# CITY OF LA CAÑADA FLINTRIDGE

## PLANNING COMMISSION STAFF REPORT

Variance 17-08

4201 Mesa Vista Drive

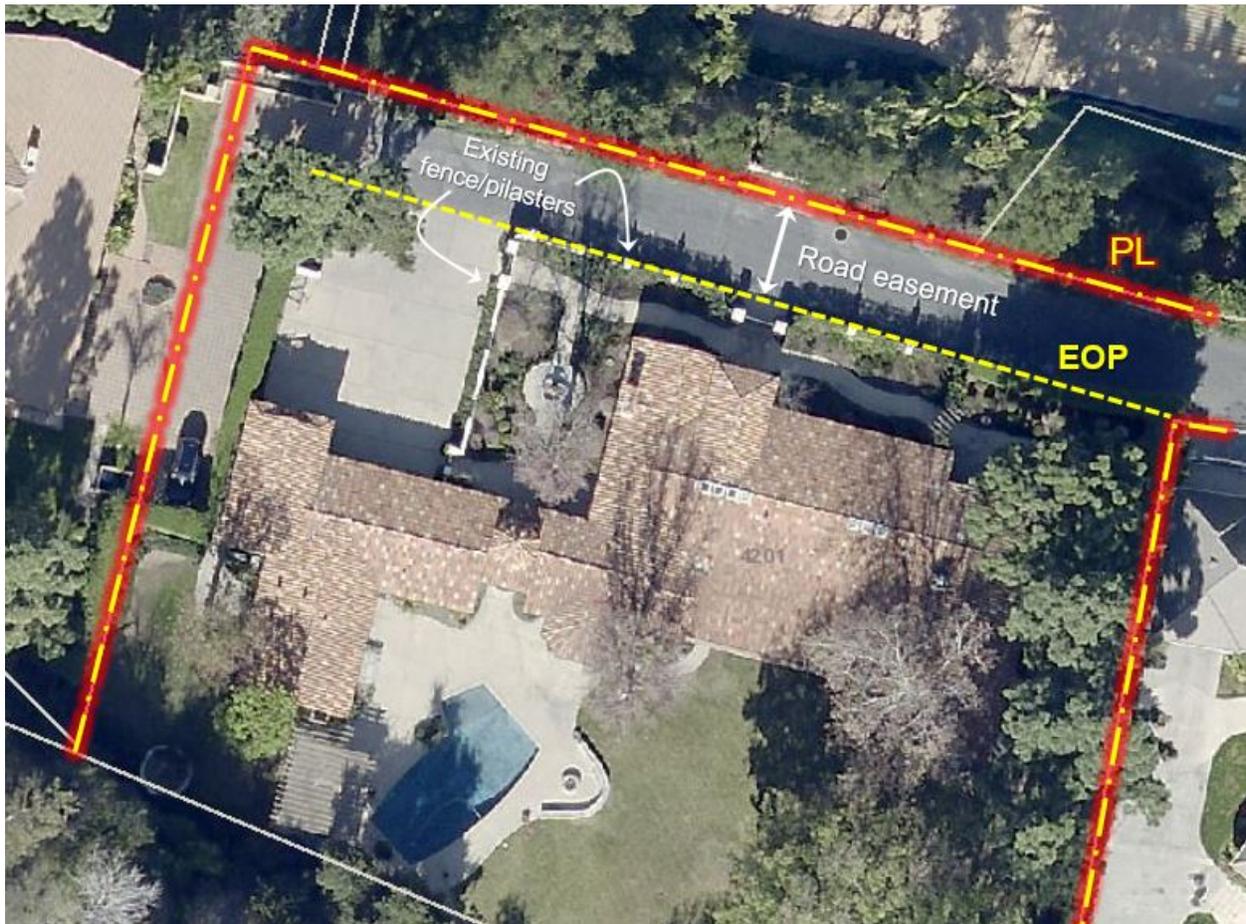
Of significance is the lot's position along a private, rather than public, street. This section of the street is actually an easement over the subject lot, with the front property line along the north side of the street, not the south as it appears. As is customary, code interprets the net lot area as that contiguous portion exclusive of area within the easement. Further, the front property line defaults to the edge of pavement (EOP). The following exhibit is purposeful in understanding the configuration of the subject lot.

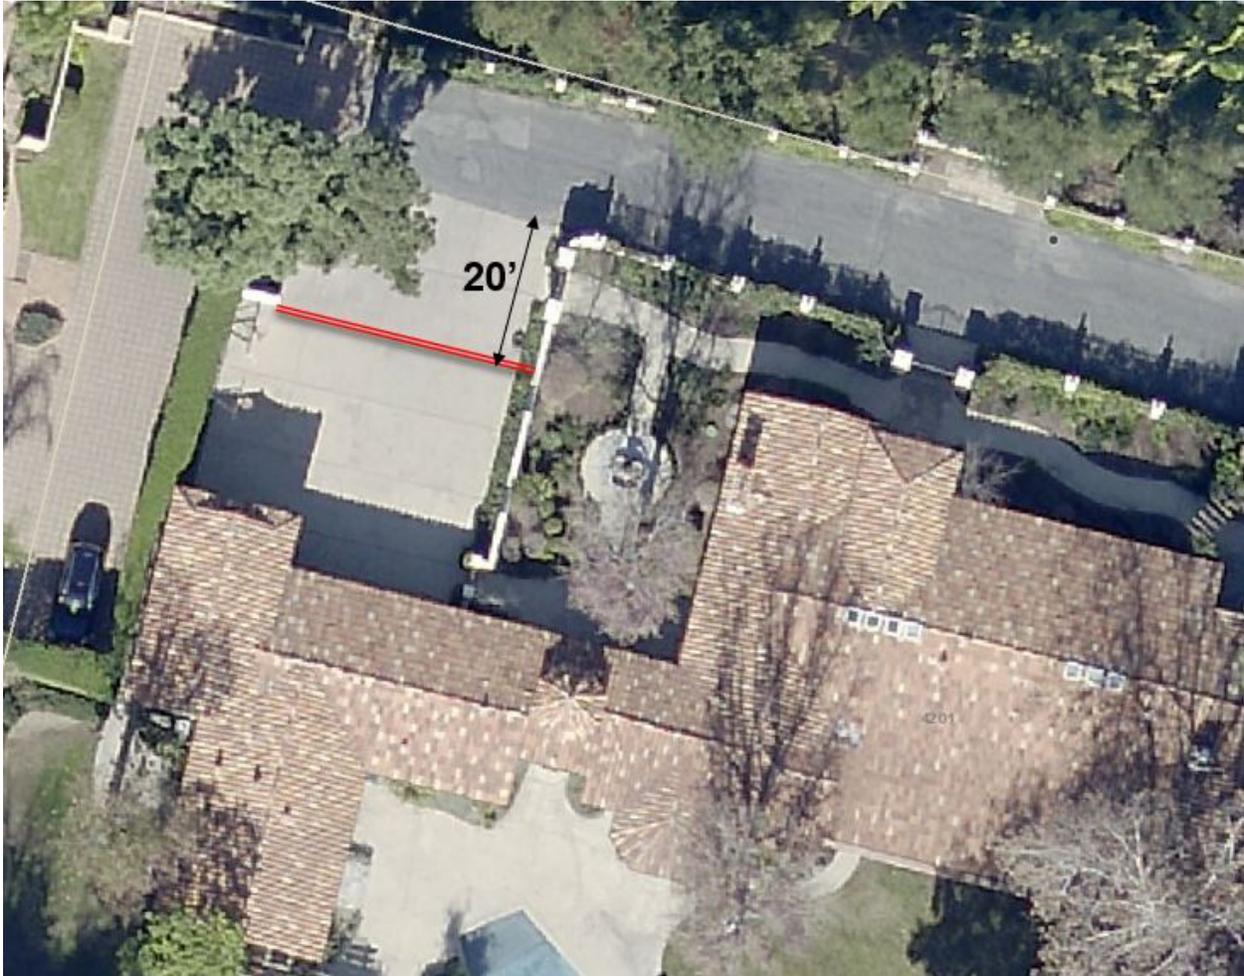
Imposition of the stacking setback for the new driveway gate seems severe considering it would create an obstruction that awkwardly bisects the mid-section of the auto-court (photo below), visually emphasized from longstanding existing fencing along the edge of pavement that would be retained to the east and extended to the west through the Fence Review process.

10. Fence Review approval shall be required prior to issuance of building permits for the fence and/or driveway gate.
11. Driveway gate width shall not exceed 20 feet per code.
12. A minimum of 24 feet of turn-around space shall be provided between the face of the driveway gate and north edge of the roadway, clearly demonstrated on a revised plan to be reviewed and approved by the Director of Community Development prior to plan check submittal.
13. Fire Department review and approval of the project shall be verified prior to plan check submittal.
